IN THE MATTER OF AN APPLICATION TO
AN BORD PLEANÁLA

FOR APPROVAL OF THE FOYNES TO LIMERICK ROAD (INCLUDING
ADARE BYPASS) COMPRISING:

Brief of Evidence

Responses to Submissions on Engineering Issues

Figure 7.1 O'Connor Property at Rathkeale – O'Connor Property shaded blue

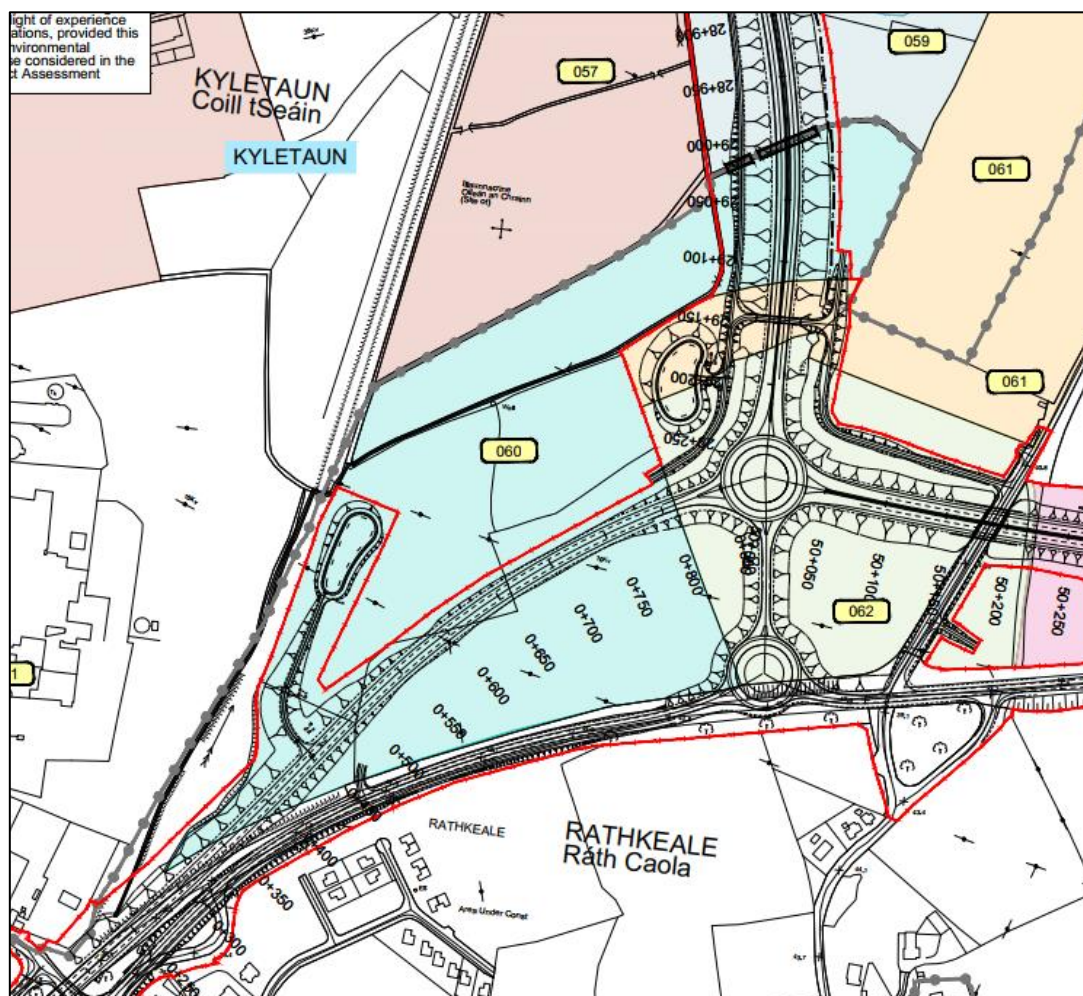
- 7.2. Submission SCH-11 refers to the property of Catriona O'Connor (Ref.404) at the north-western side of the proposed Rathkeale junction. The property is a field as shown in Figure 7.1. All of the lands contained in the Schedules to the Schemes are necessary, sufficient and/or suitable for the Proposed Road Development to which the Protected Road, Motorway and Service Area Schemes relate.

Notwithstanding the foregoing, and as suggested in the objection, in the event the scheme is confirmed, Limerick City and County Council will at that stage, be willing to re-examine the proposal for the purchase of the entire property subject to negotiations and agreement.

Figure 7.2 Culhane House at Clonshire More (Extract from Figure 16.17 of Volume 3)

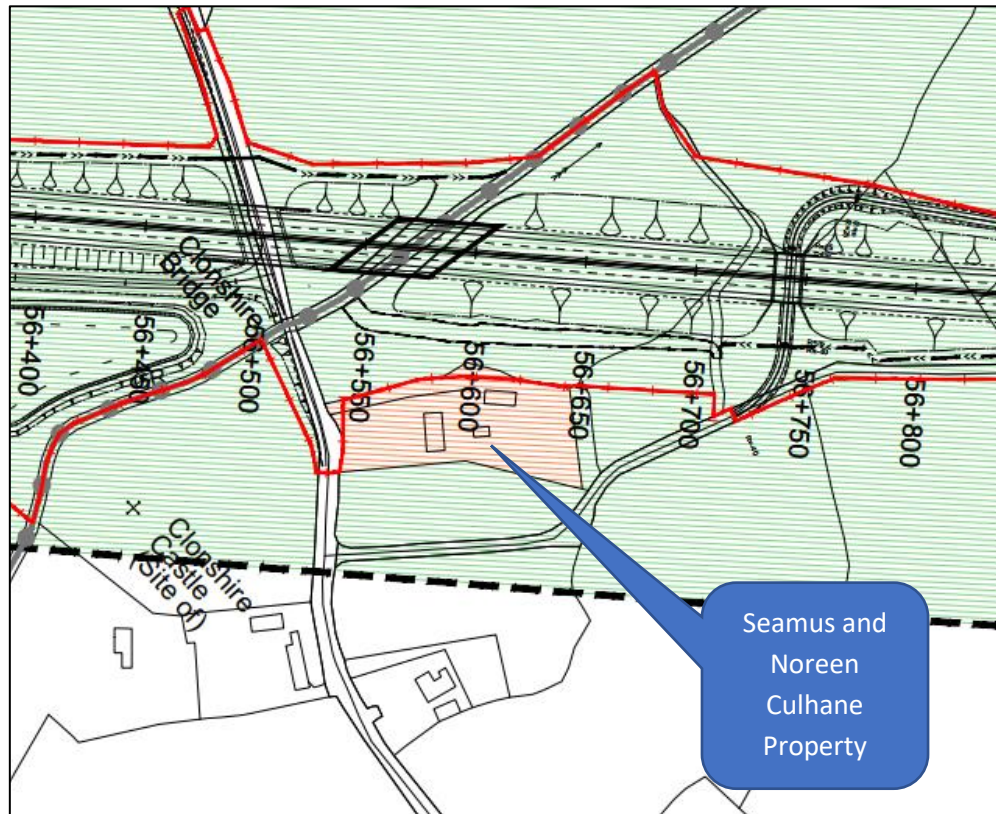
- 7.3. Submission SCH-103 refers to the property of Seamus & Noreen Culhane at Clonshire More (Ref.447). The house is located about 50m from the proposed motorway embankment as shown in Figure 7.2. In the event that the proposed road development is confirmed, Limerick City and County Council will at that stage, be willing to re-examine the proposal for the purchase of the entire property subject to negotiations and agreement.

Figure 10.1 Relationship of Proposed Road to Gilvarry House at Clonshire Beg

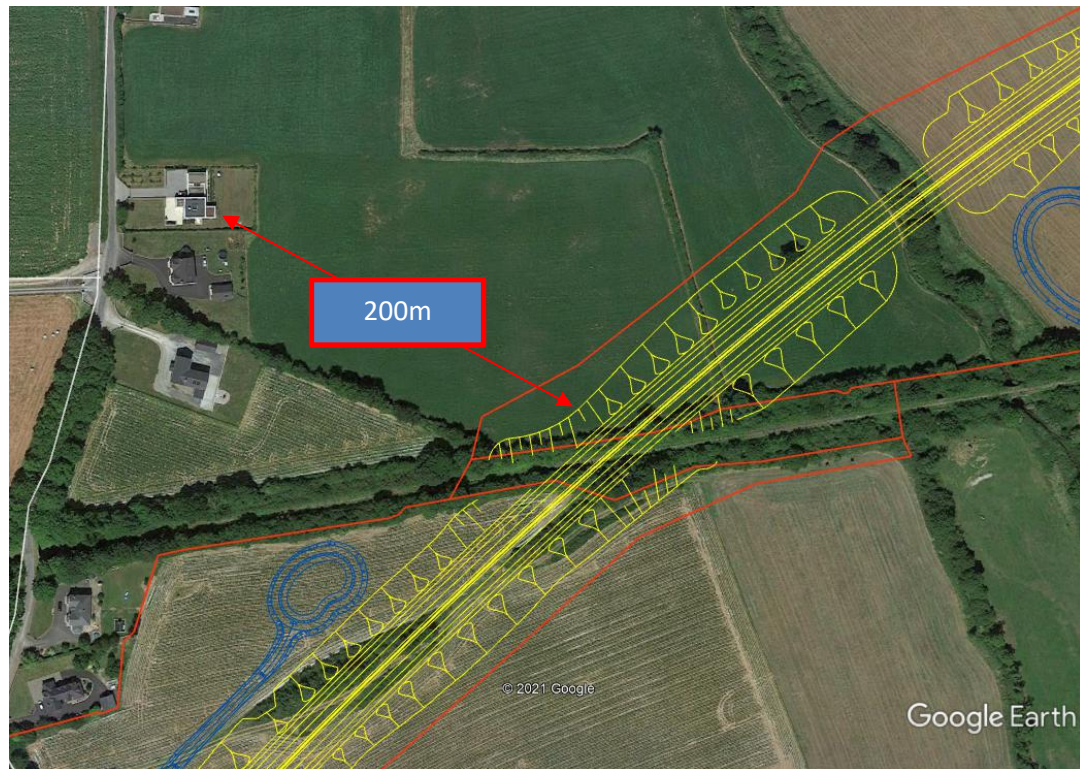
- 10.5 Submission ENV-13 (Ian Gilvarry): The house was designed to use the sunlight and daylight pattern changes during the day and the annual seasons. This detail will be affected due to the road being on elevated ground rendering the house design unfit for purpose.

- 10.6 The house in question is located about 200m northwest of the proposed road as shown in Figure 10.1. The proposed road will be at an elevation of 16m OD at the railway bridge crossing, which is 7m above ground level, and the level at the house. The vertical angle from the house to the proposed road is therefore just 3 degrees above the horizontal towards the southeast, which cannot cause any loss of sunlight at this house. The existing view towards the southeast from this house shows a line of tall trees along the railway line which are higher than the proposed road.

Figure 11.2 Proposed Road at Curraghbeg

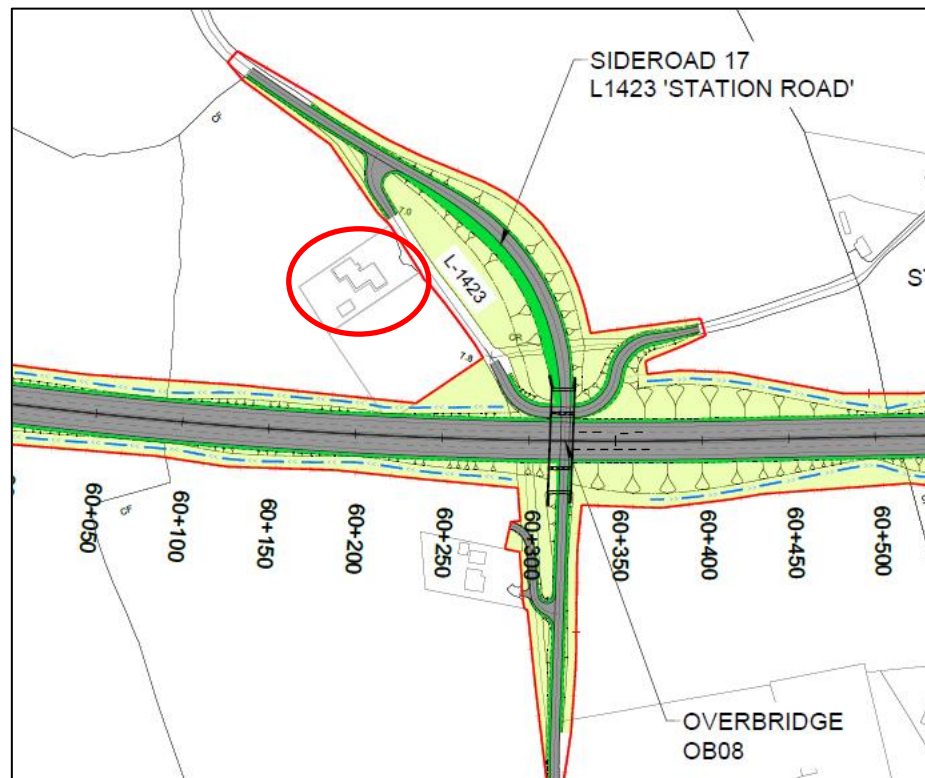
- 11.3. Submission SCH-60 on behalf of Hugh Boyd of Curraghbeg, Adare: No detail regarding the levels of the proposed motorway and realigned county road.

- 11.4. As shown in Figure 4.11.1 below (an extract from Figure 4.46 in Volume 3 of the EIAR) the proposed mainline road will be largely at ground level near the house in question (circled in red). Local road L-1423 will be realigned away from this house and will be at a height of about 3m above ground level where it will be closest to the house. The

local road, L-1423, was previously approx. 25m from the front of the house and after construction will be approx. 50m from the front of the house.
